JOINT AGENCY REVIEW TEAM (JART)

PORT COLBORNE QUARRIES INC. - PROPOSED PIT 3 EXTENSION CITY OF PORT COLBORNE

JART REPORT

September 2023

Figure 3 - Port Colborne Minimum Temperatures (1965-2006)

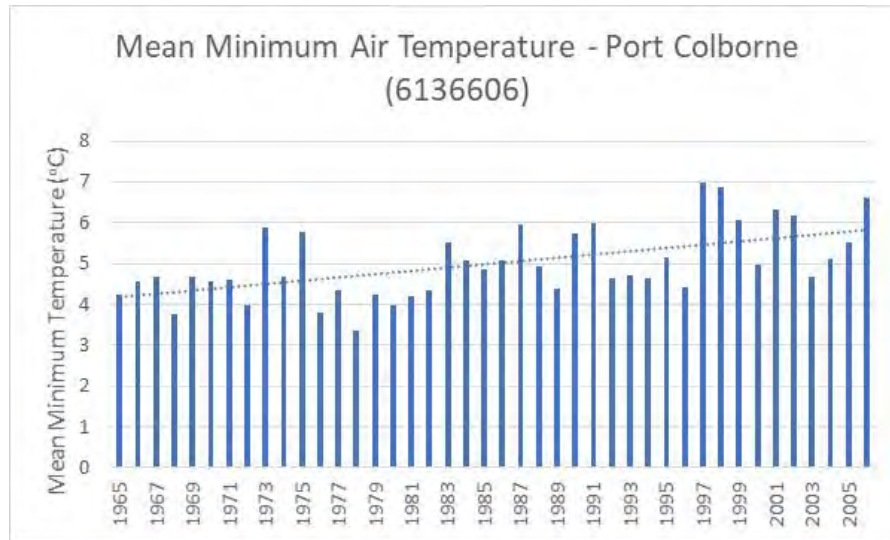
11. Table D-1 presents the monthly water budget over the 1965-2018 time frame. Is the 1965-2018 time frame reflective of the climate conditions currently experienced in the study site? As the climate has warmed since the mid-60's (see Figure 3), using this time period may not be reflective of current evapotranspiration rates. Are the water budget calculations sensitive to using a more recent 20 year period?

11. Table D-1 presents the monthly water budget over the 1965-2018 time frame. Is the 1965-2018 time frame reflective of the climate conditions currently experienced in the study site? As the climate has warmed since the mid-60's (see Figure 3), using this time period may not be reflective of current evapotranspiration rates. Are the water budget calculations sensitive to using a more recent 20 year period?
